Palo Verde Nuclear
Generating Station

**Subject: Palo Verde Nuclear Generating Station (PVNGS)
Units 1, 2, and 3
Docket Nos. STN 50-528, 50-529, and 50-530
Request for Amendments to Technical Specification (TS) 3.5.5,
Refueling Water Tank (RWT), to Increase the RWT Minimum Water
Level for Units 1 and 3 and Incorporate Editorial Changes for
Units 1, 2, and 3**

Evaluation of the Proposed Change

FIGURE 3.5.5-1
Minimum Required RWT Volume

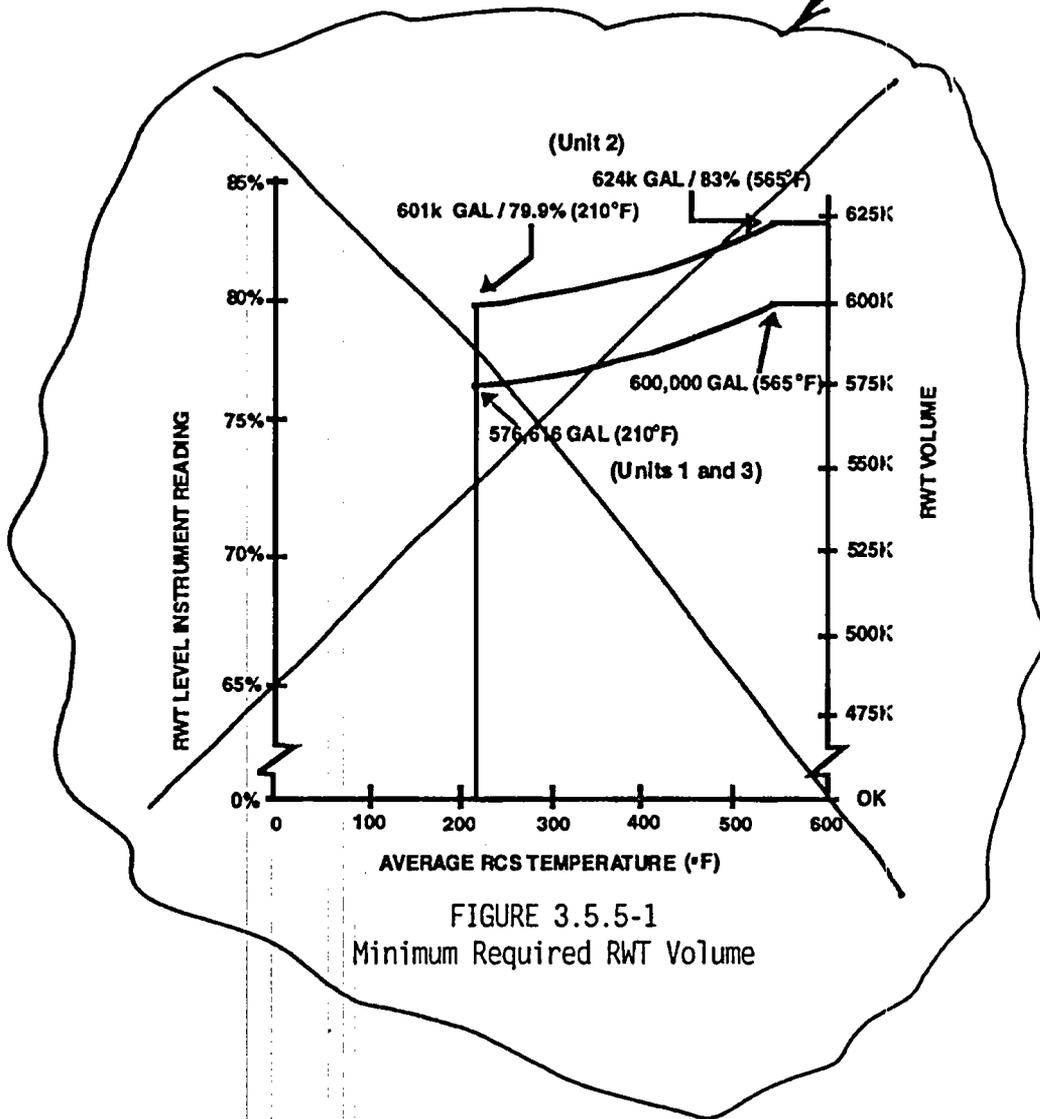
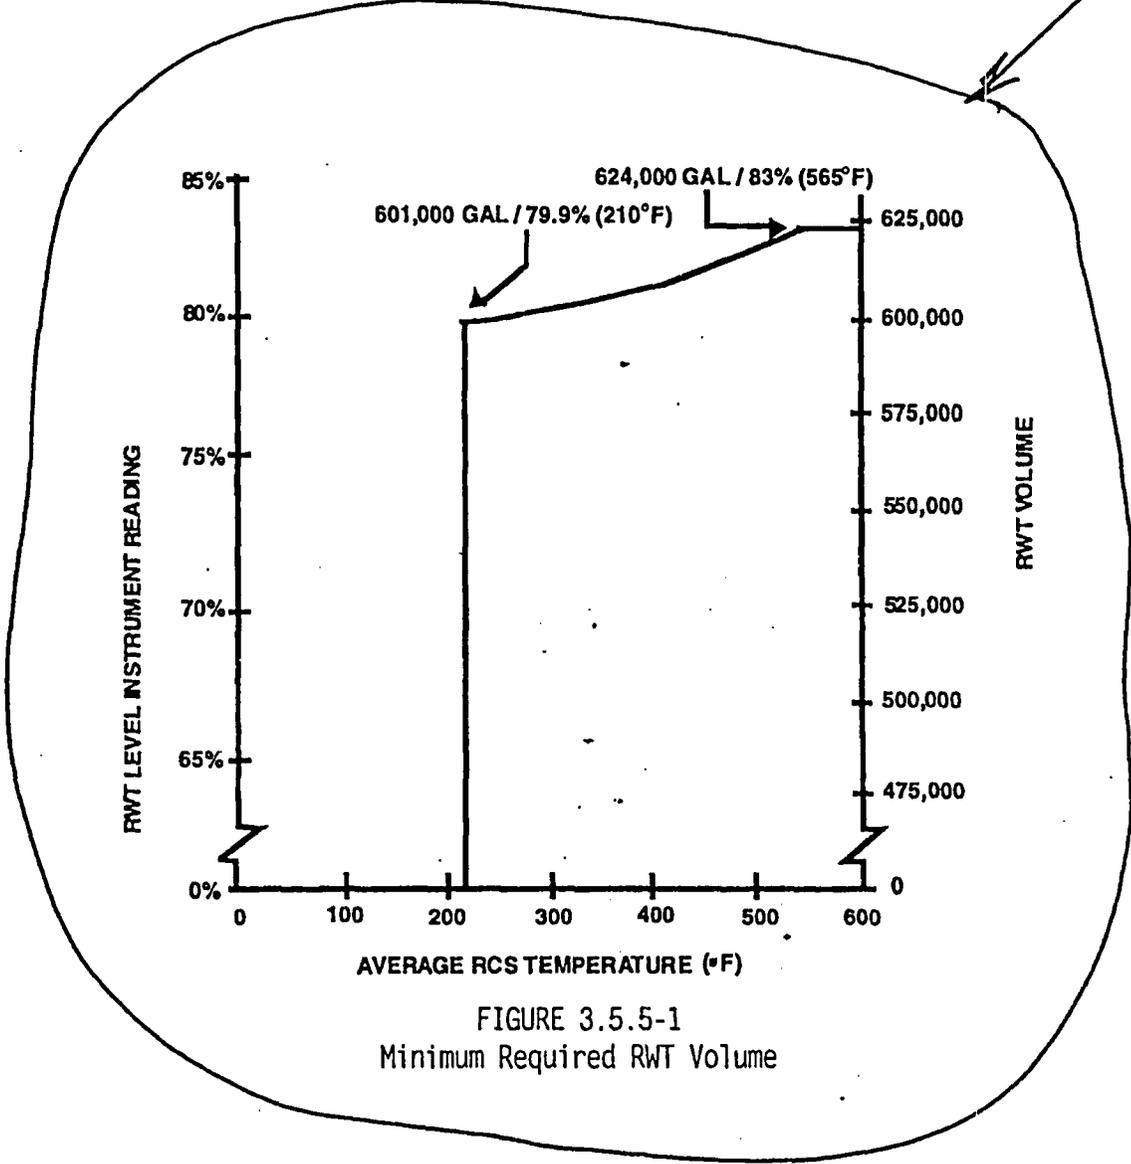
The editorial component of the proposed amendment serves to provide consistent formatting of the volumetric values provided in TS Figure 3.5.5-1 for PVNGS Units 1, 2, and 3. Specifically, TS Figure 3.5.5-1 currently uses two different formats to designate the volume information provided. It either provides only the whole digits above one thousand followed by a "K" to designate a multiplier of one thousand (e.g., 600K), or the full volume numbers are written out (e.g., 600,000). For consistency, the volume information provided in the figure is changed such that it is presented in full number format.

Page:
3.5.5-3
Attached Figure

Replace with ATTACHED Figure

~~PALO VERDE UNITS 1 AND 3~~
~~PALO VERDE UNIT 2~~
UNITS 1, 2, 3

Replacement Figure For Figure 3.5.5-1

FIGURE 3.5.5-1
Minimum Required RWT Volume

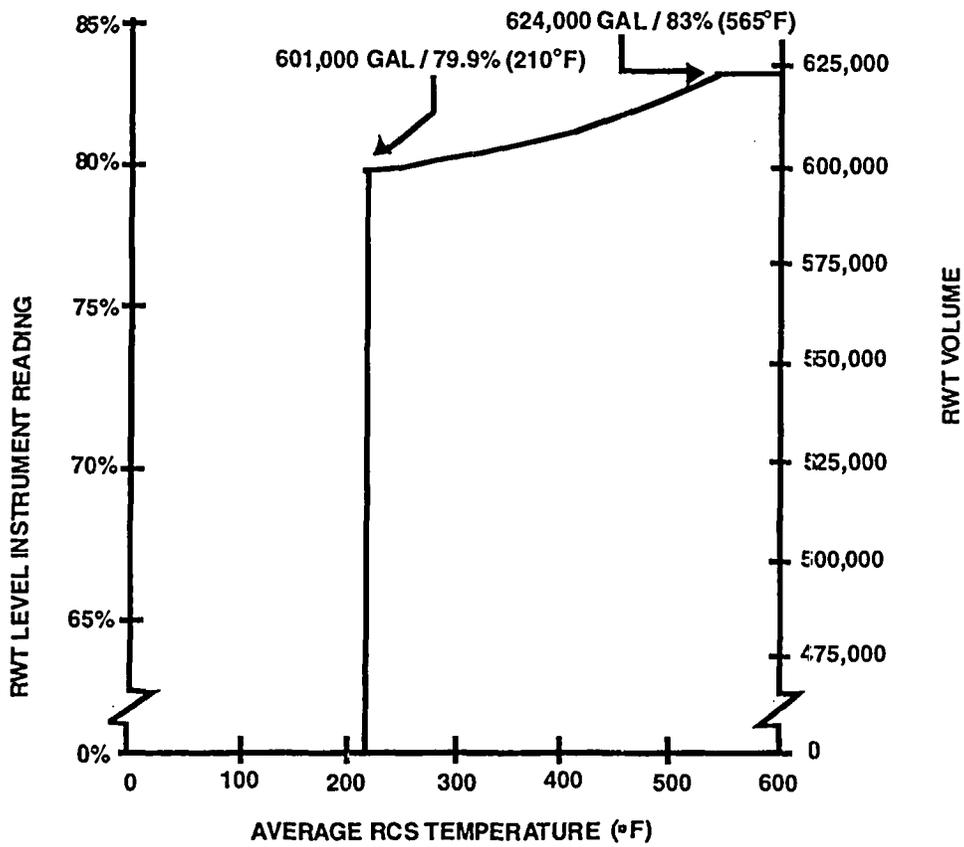
Retyped Technical Specification

**Page:
3.5.5-3**
